PROPOSED CONSTRUCTION OF A WIND
ENERGY FACILITY AND ASSOCIATED
INFRASTRUCTURE ON A SITE NEAR
HOPEFIELD IN THE WESTERN CAPE
DEA ref: 12/12/20/1302

MOTIVATION FOR AMENDMENT OF
ENVIRONMENTAL AUTHORISATION -
SUBMISSION TO NATIONAL DEA

SITE DEVELOPMENT PLAN (DRAFT)

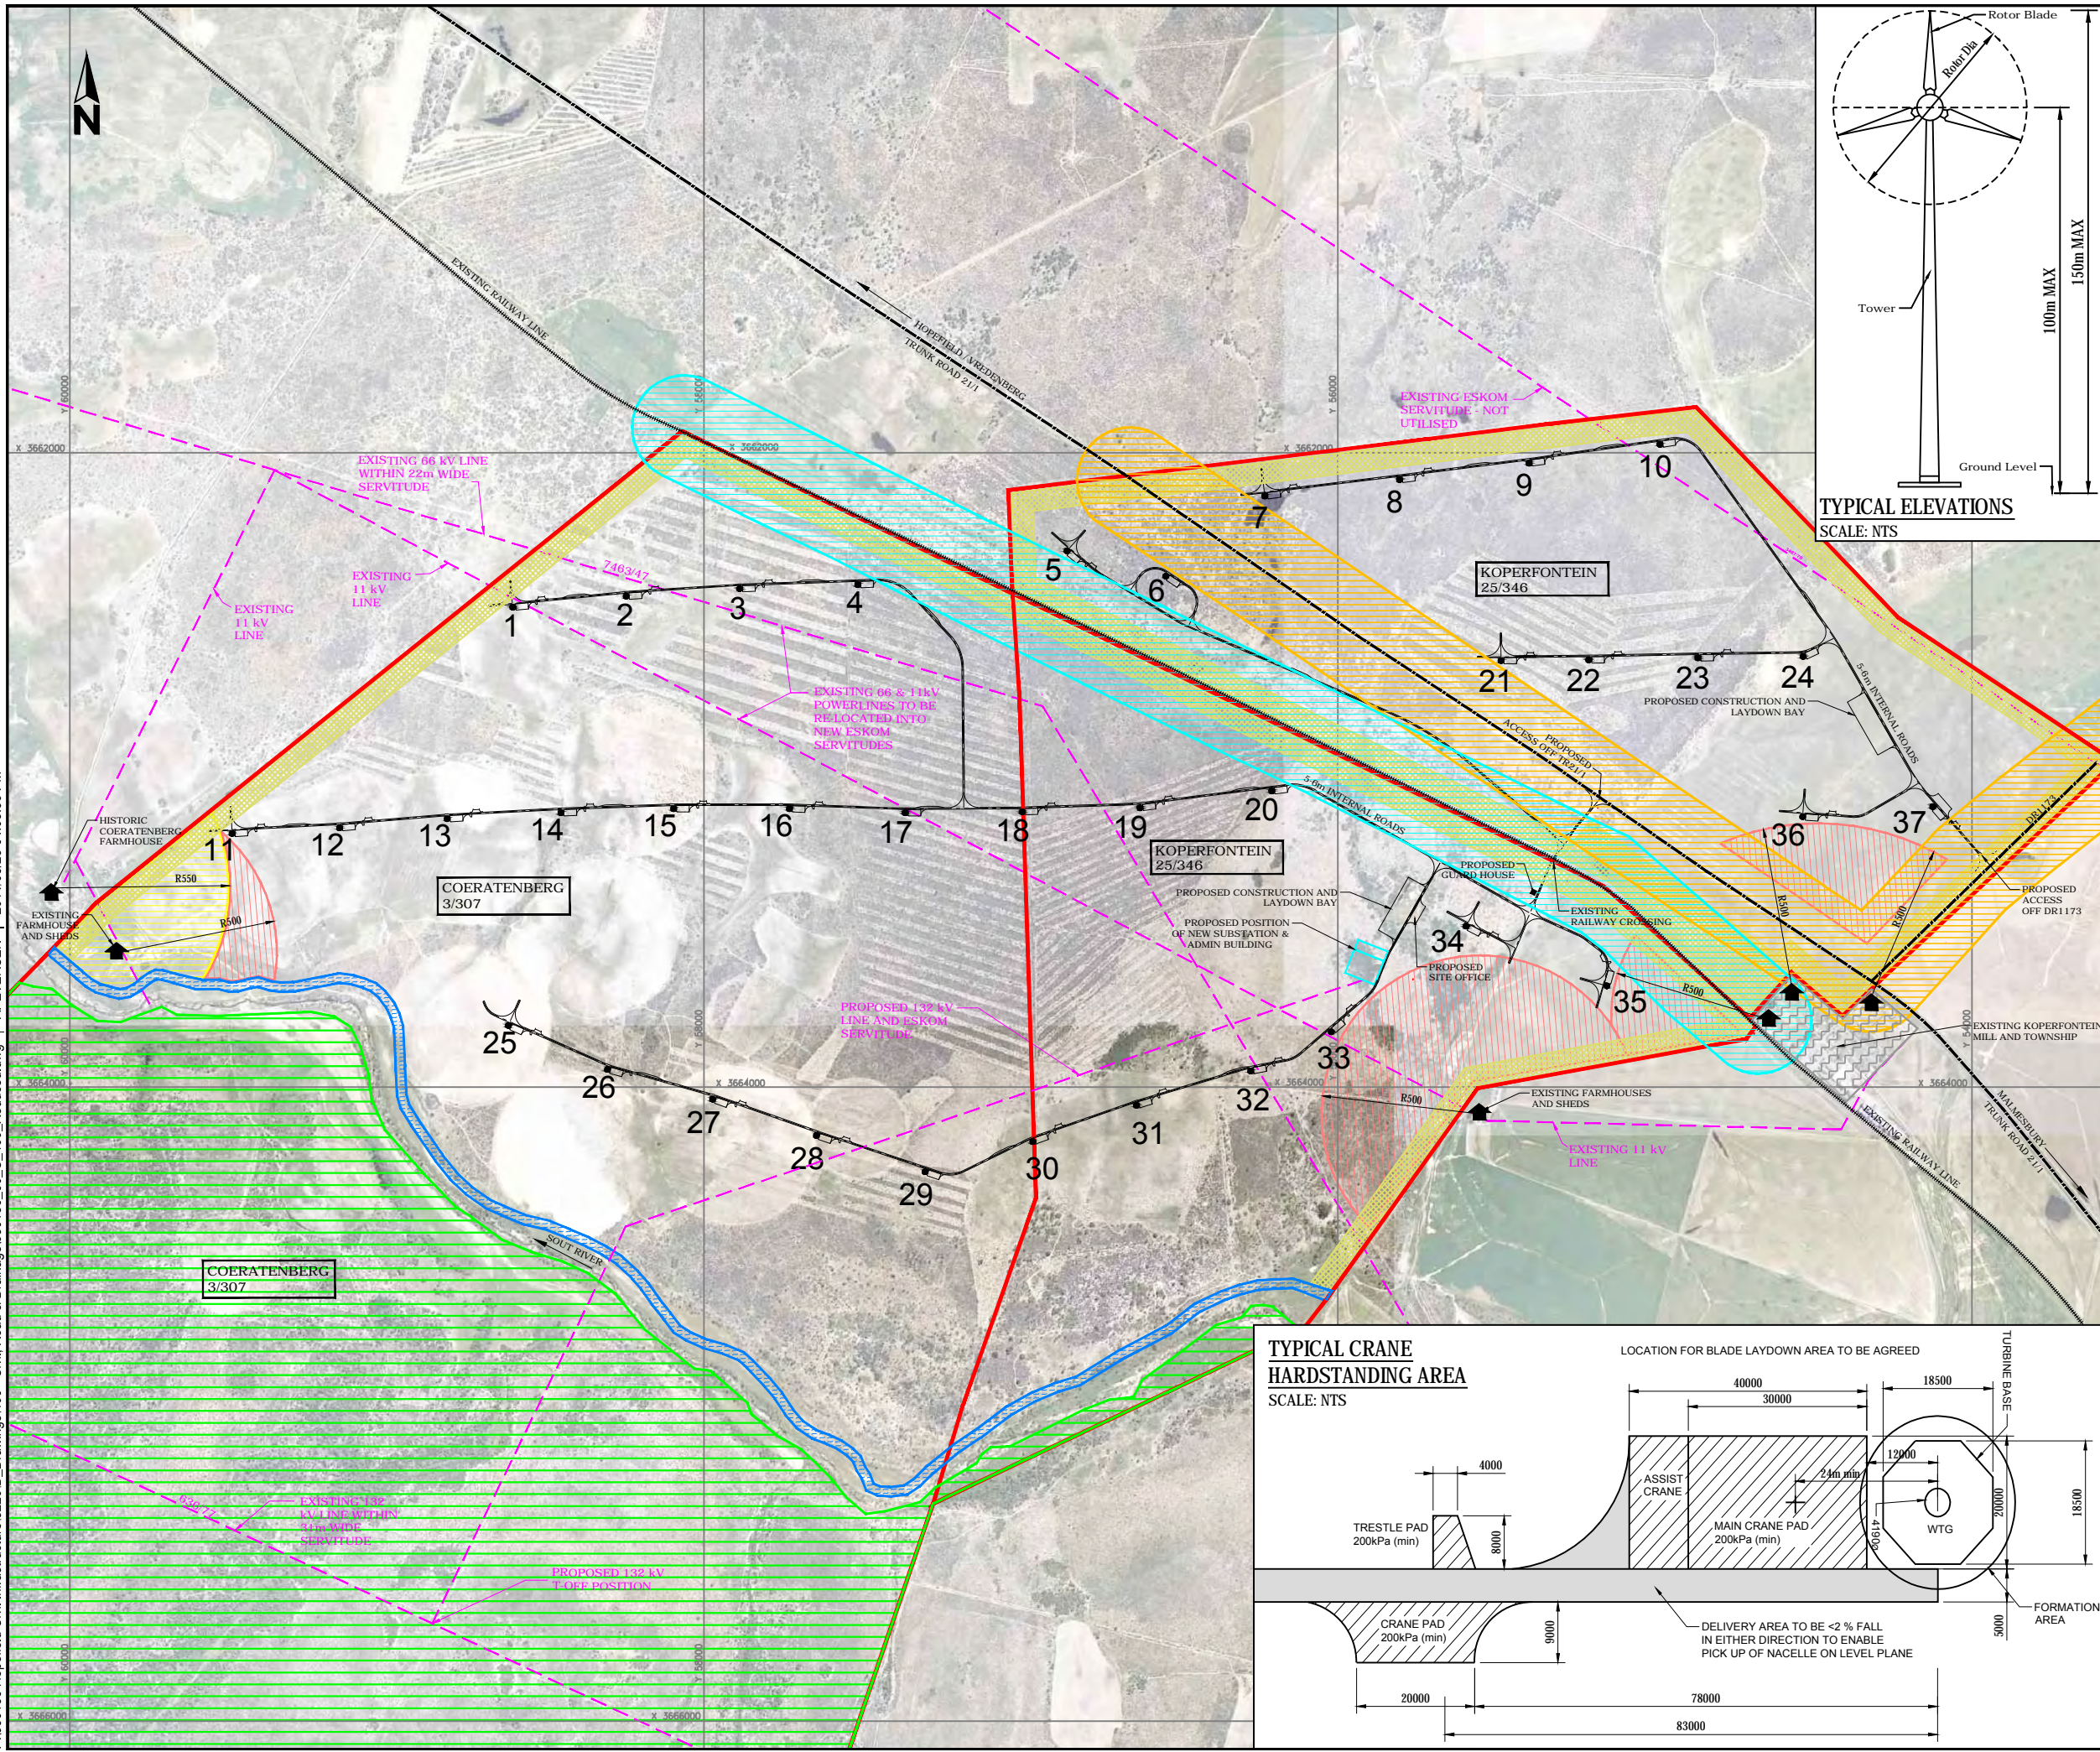
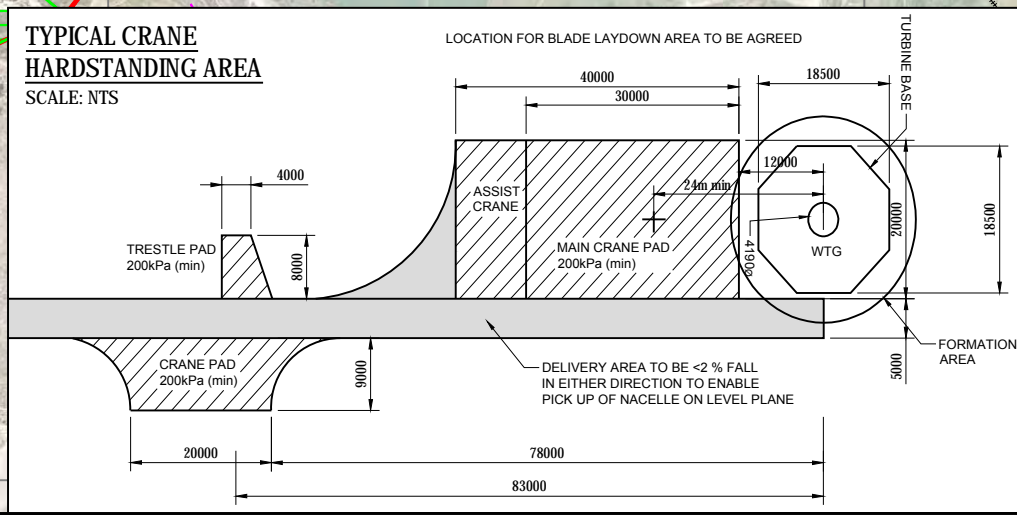
Should the amendment be granted, the indicative 40-turbine layout provided by Umoya Energy is illustrated in the attached Figure 1 (Site Development Plan). Figure 2 provides detail on how the 50-turbine (assessed in the EIA) and the ~40-turbine (as now proposed) layouts differ.

Figure 4: Potential visual exposure of 37 wind turbine positions calculated at 95m above ground level (Note: the potential visual exposure is very similar to Figure 2, but the frequency of exposure is lower due to the reduced number of turbines; i.e. categories for 40 – 50 turbines not applicable)

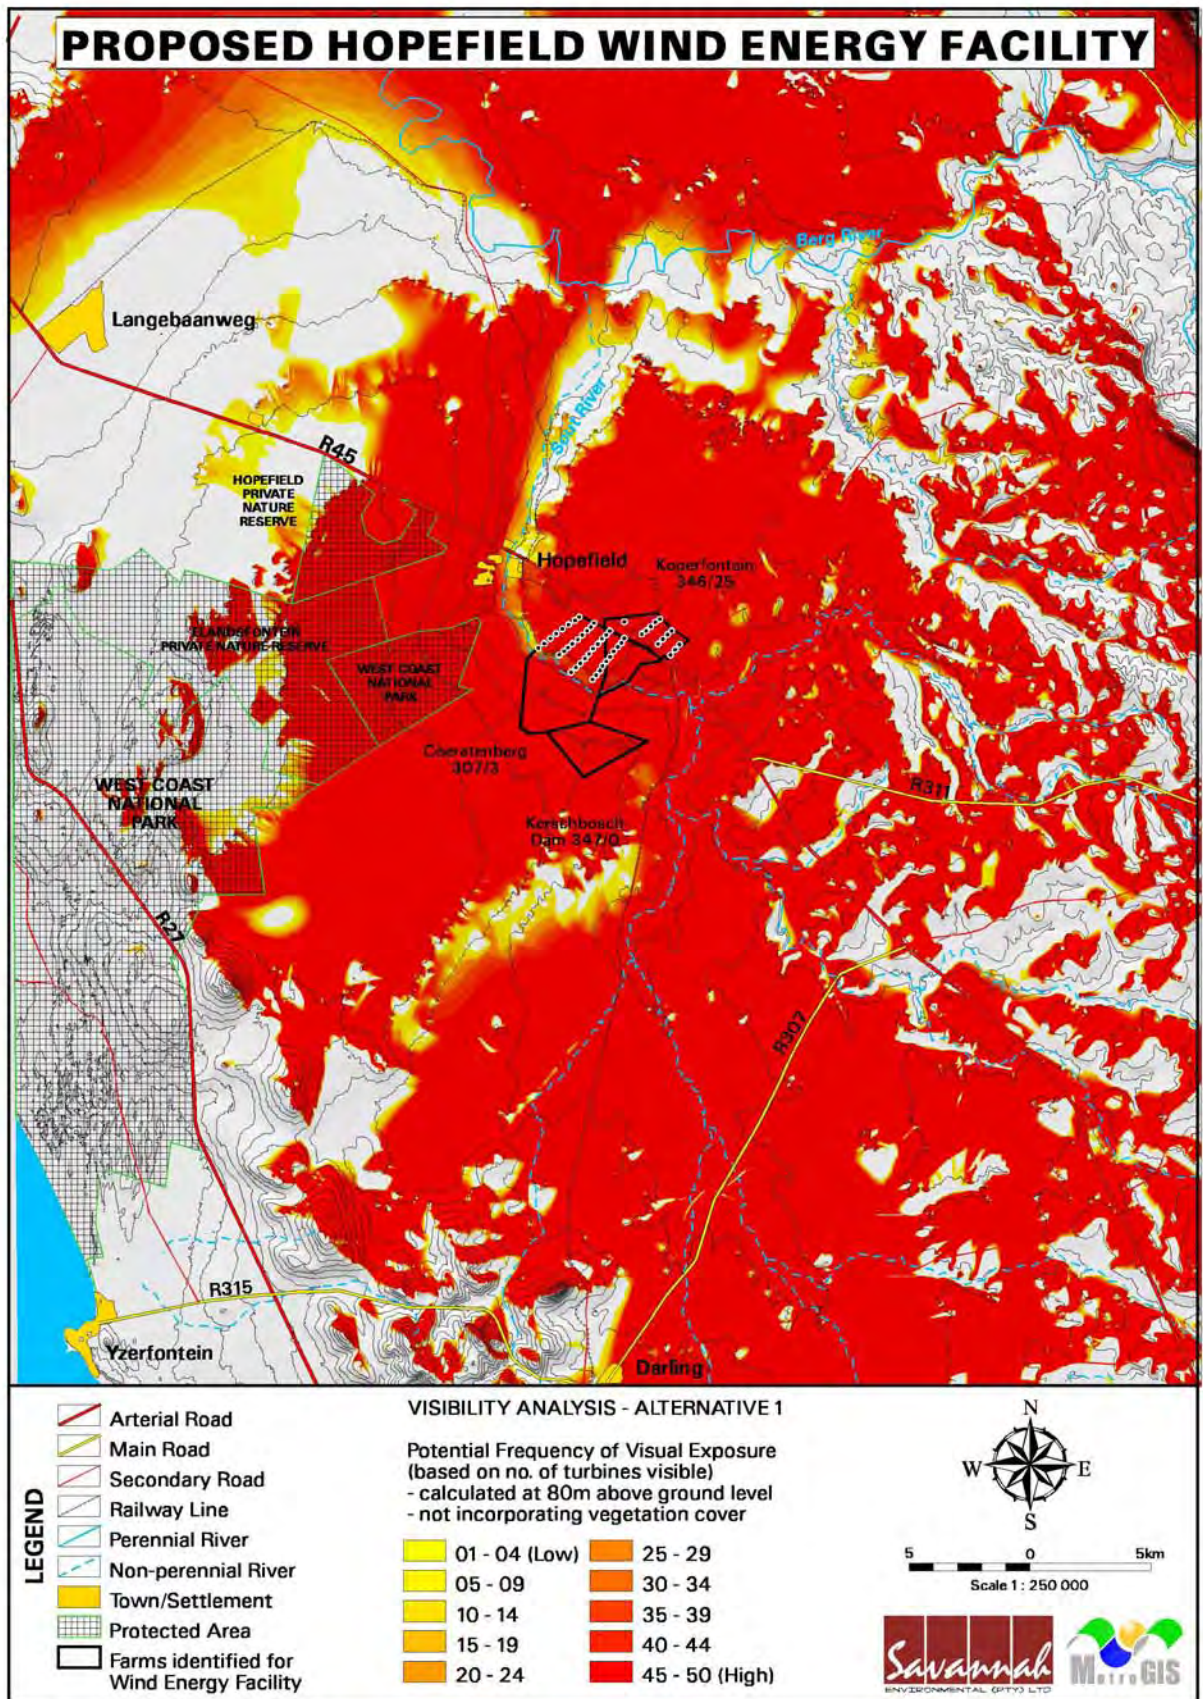
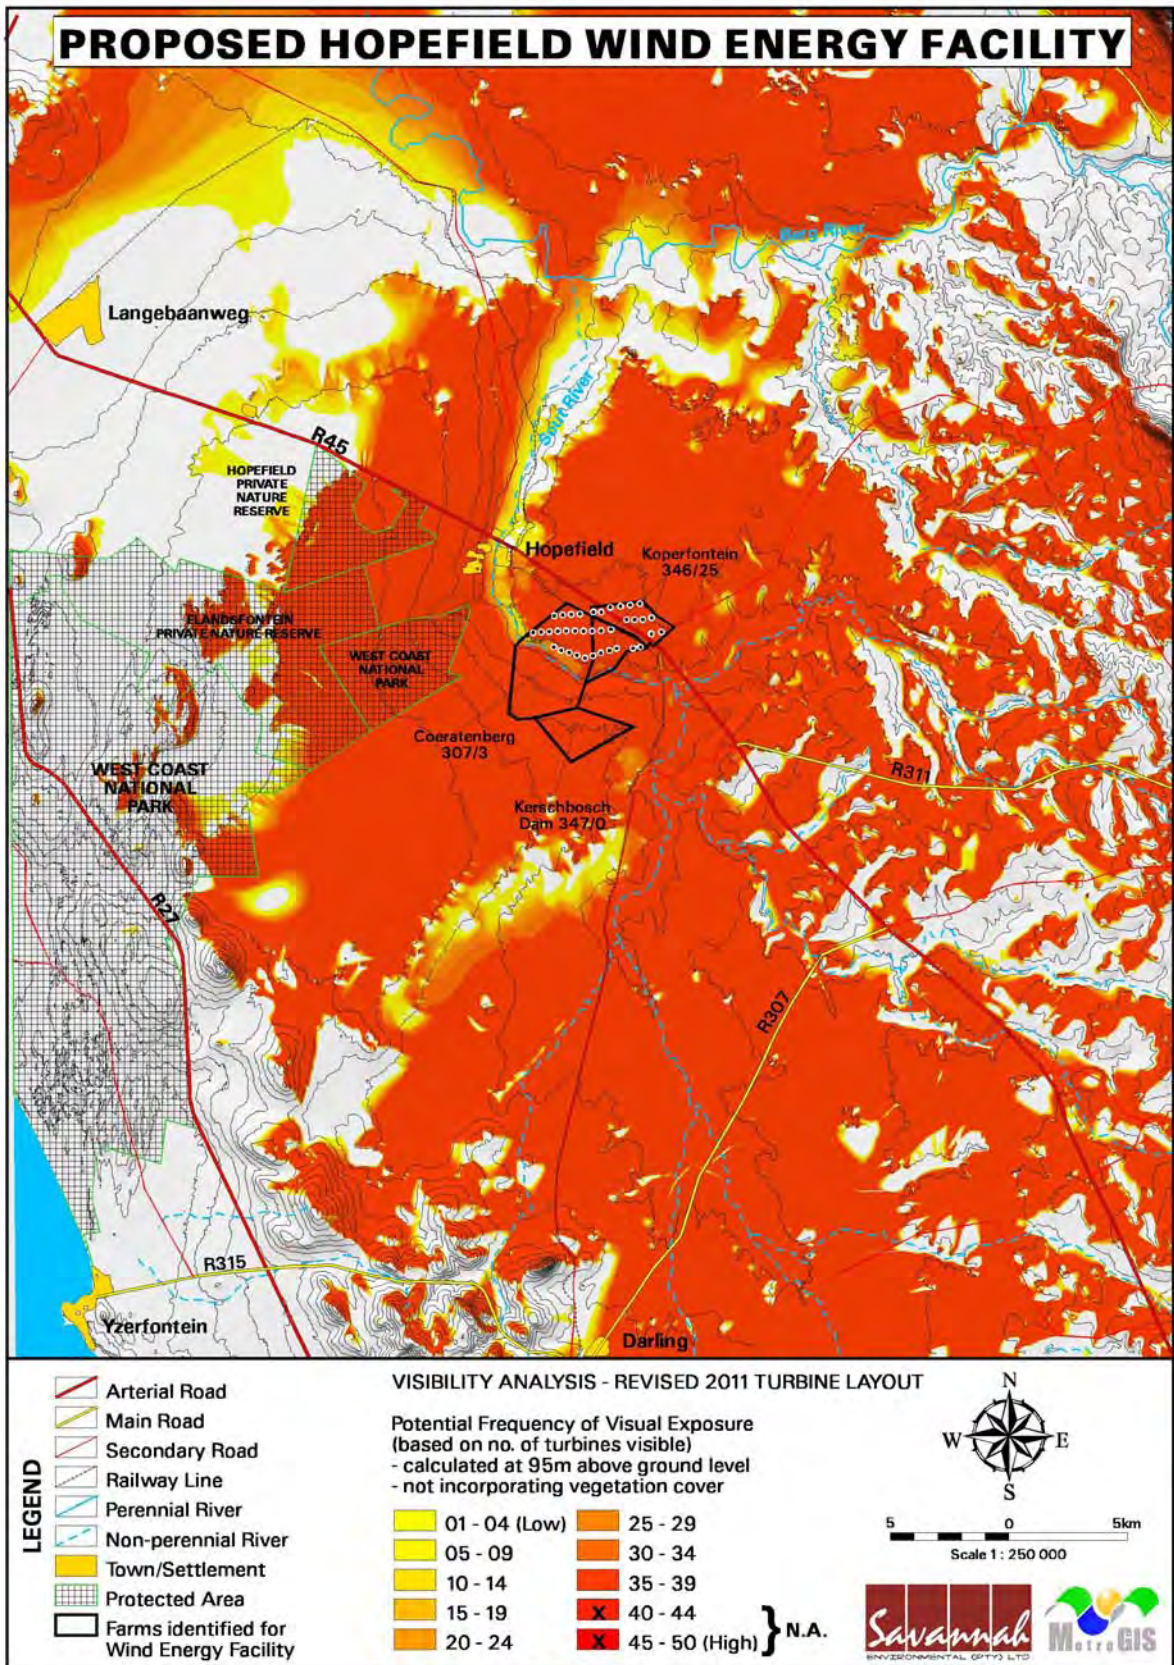
A comparative viewshed analysis has been undertaken in order to be able to draw a comparison between the potential visibility of the facility as per the authorised 50-turbine layout (original layout), and the now proposed maximum 40-turbine layout (revised layout). From the comparative viewshed analysis undertaken, it can be concluded that the medium- to short-distance observation (and potential visual impact) of the two alternatives will be very similar (refer to Figures 3 and 4), but that the potential frequency of visual exposure will be less/lower due to the reduced number of wind turbines. This is especially valid in locations where the absence of other familiar structures makes it difficult to judge the scale of the wind turbines. To this end, the construction of fewer turbines (even if they are taller) would be favoured for short to medium distance sightings.

When considering the two alternatives under investigation from a broader (regional) scale (i.e. at distances in excess of 10 km), it has been concluded that the slightly smaller, less imposing 80 m hub height turbines would be marginally less conspicuous.

Therefore, the two alternatives are considered to be very **similar** from a visual perspective. It is envisaged that the structures would be easily and comfortably visible regardless of the hub height selected, especially within a 10 km radius of the wind energy facility.
